Planning Commission

Planning Commission Meeting Agenda
Hartland Township Hall
Thursday, May 26, 2022
7:00 PM

Hartland Township Planning Commission Meeting Agenda Memorandum

Subject: Site Plan Application #20-011 Villas of Hartland Planned Development (PD) – **REVISED** Preliminary Site Plan dated February 24, 2022

SITE PLAN

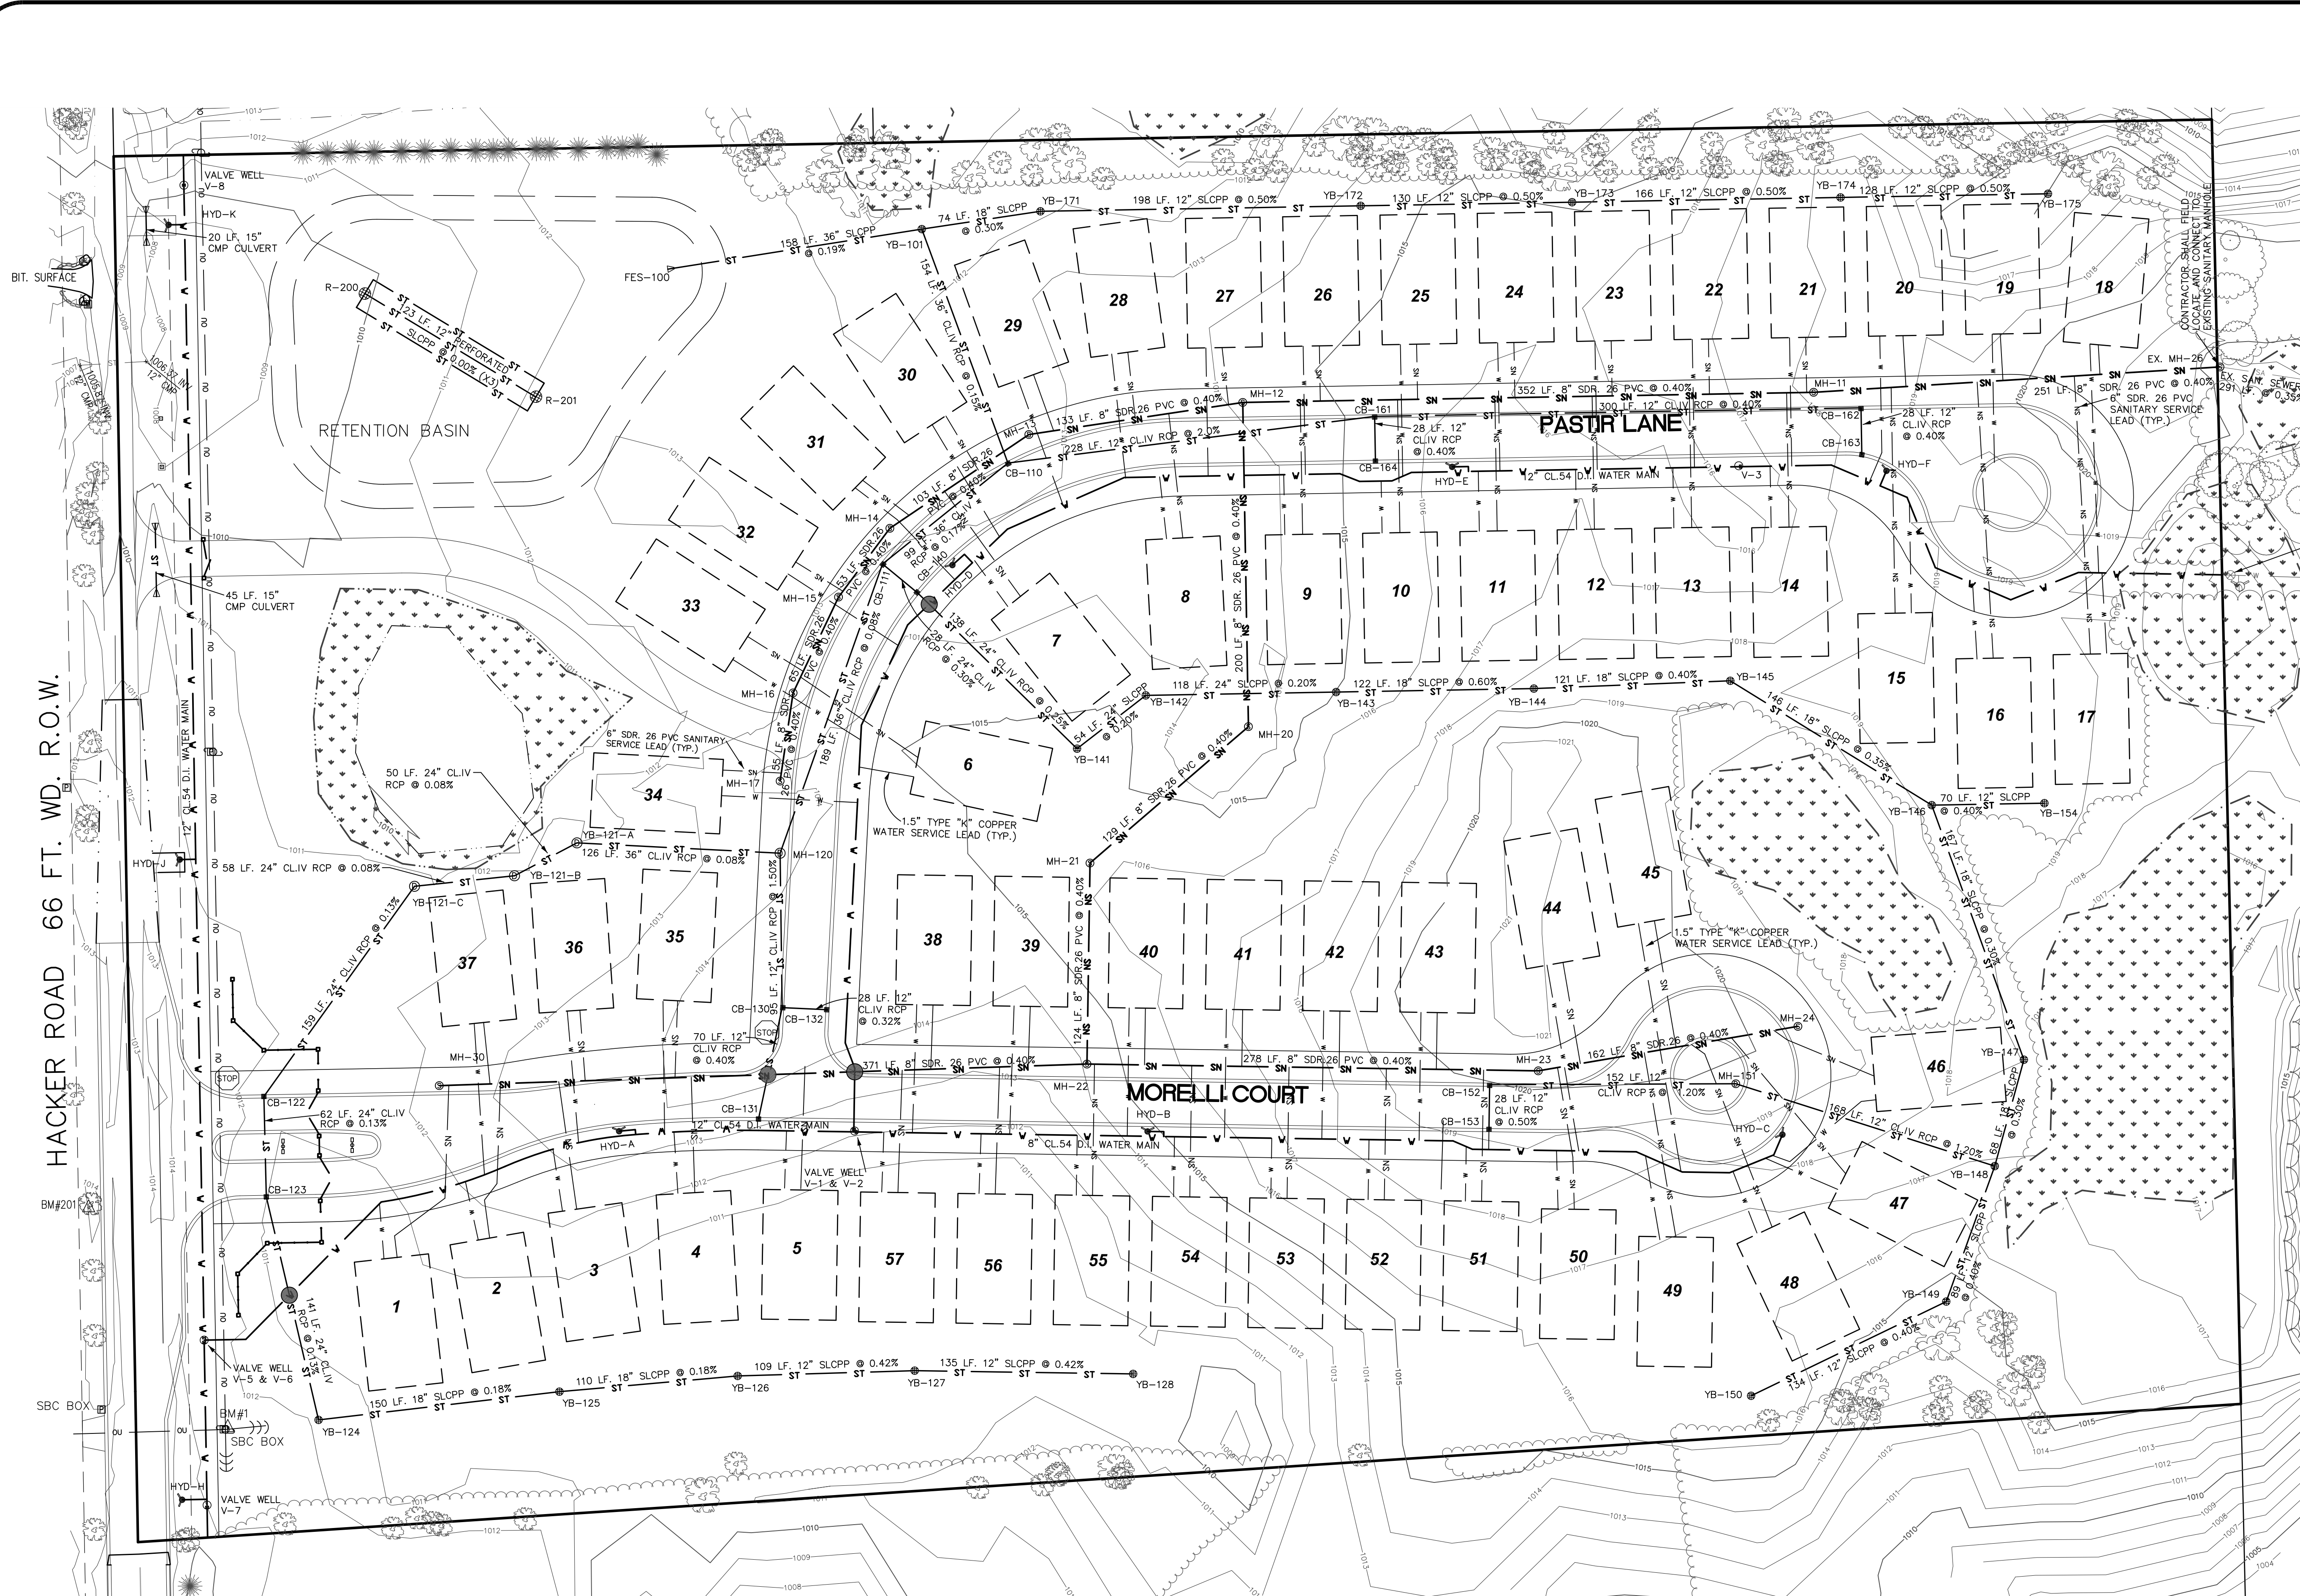
The residential units are shown with dashed lines and labeled as "Typical unit envelope." The envelope dimensions are stated as 46 feet wide and 80 feet deep, or approximately 3,680 square feet (0.084 acres) in area. Building setbacks are not stated or shown, nor is the distance between buildings/structures. Staff assumes the intent of the proposed unit envelope is that each residential structure and associated accessory structures, including pools and sheds, will be located within the envelope; however, the applicant should provide clarification on this matter. Lot coverage within the unit envelope is not stated on the plans.

The distance between unit envelopes, at the closest point (front line facing the street), is generally fourteen (14) feet. Distances between unit envelopes vary at the side and rear sides of the envelope. The front setback along a street is not stated on the plan however most of the unit envelopes are placed twenty-five (25) feet as measured from the building envelope to the edge of the 66-foot-wide right-of-way private road easement.

The plan shows unit envelopes, within which all structures are to be located. Building footprints are not provided within the unit envelopes. The closest spacing between unit envelopes is fourteen (14) feet. If the house in each unit was at the unit envelope line, the distance between the structures could potentially be as close as fourteen (14) feet. This would not meet the minimum required spacing standards for single-family structures in a planned development. Per Section 3.1.18.C.vi.a., modification to yard setback requirements may be approved by the Township Board upon recommendation from the Planning Commission, upon making the determination other setbacks would be more appropriate.

EMERGENCY ACCESS GATE DETAIL
NOT TO SCALE

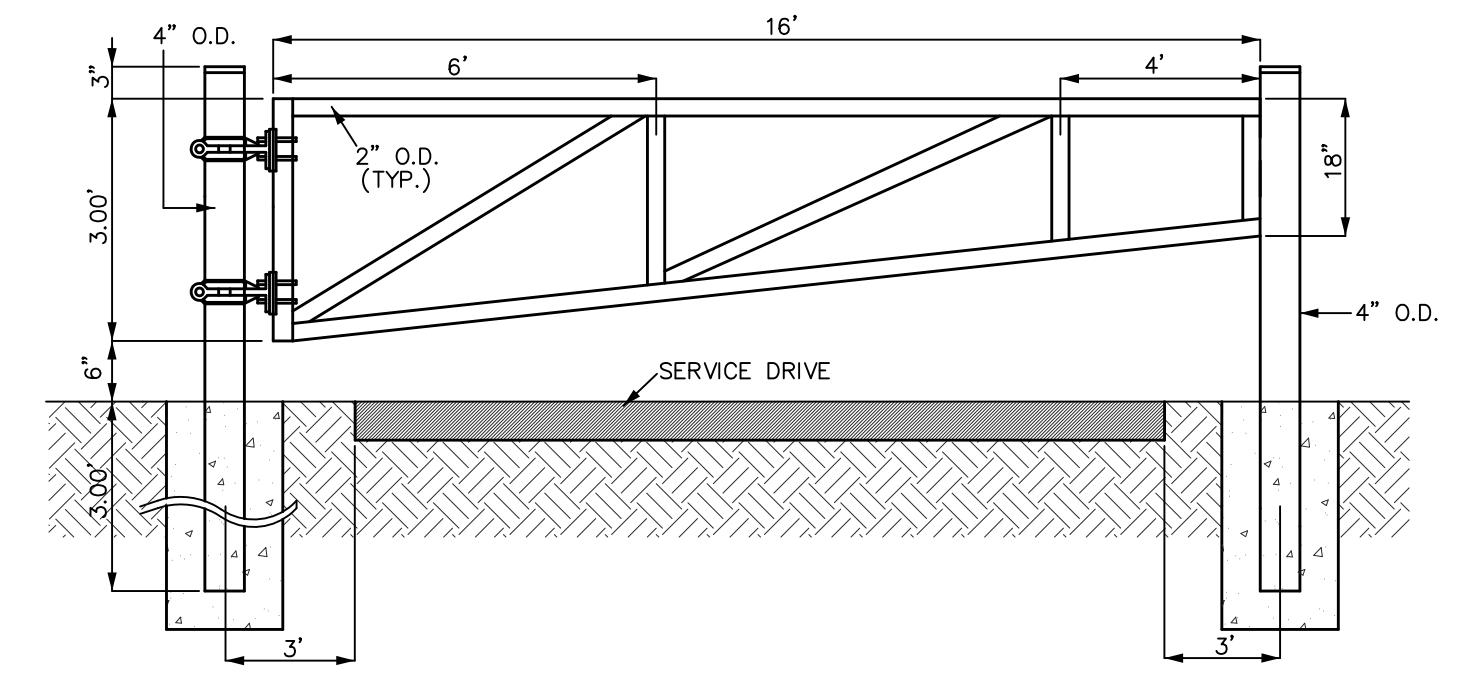
Public access to the development is via Hacker Road, with a boulevard entrance that is gated. Internal circulation is provided via private roads, with each road terminating in a cul-de-sac. A gravel surfaced, emergency access drive is proposed, from Pastir Lane to Hacker Road, on the west side of the site. The emergency access is gated at the Hacker Road right-of-way line and shown as twenty-two (22) feet wide. A detailed cross-section or profile drawing of the emergency access drive was not provided.

The Hartland Deerfield Fire Authority will provide fire protection and will review the proposed plans for fire hydrant placement and other fire safety issues. A review letter for the project, dated May 12, 2022, has been provided. The Fire Authority will work with the applicant on the emergency road, associated gates, and maintenance agreement.

CONCEPTUAL DECORATIVE GATE DETAIL
NOT TO SCALE

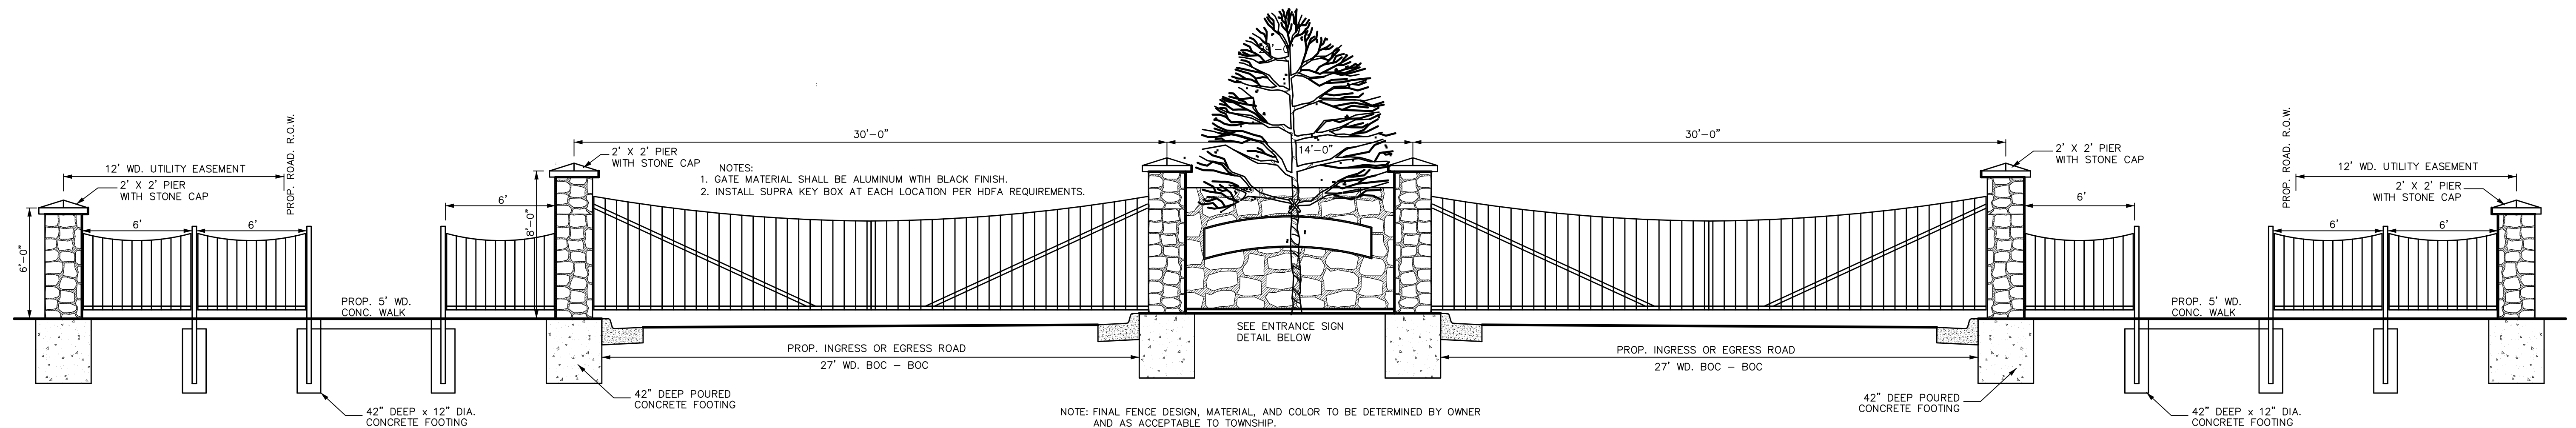
A gated, boulevard entrance provides access to the development via Hacker Road. A conceptual drawing is provided. Per the applicant the gates will be equipped with an electronic eye which will automate the opening and closing of the gates. The opening of the gates will be likely controlled by IR motion sensor or proximity loop in the pavement, per the applicant's explanation from the previous submittal. Details are not provided on the plans. Additional information will be required on how the gates for the emergency access drive operate. Clarification should be provided by the applicant and potentially be detailed in the Master Plan.
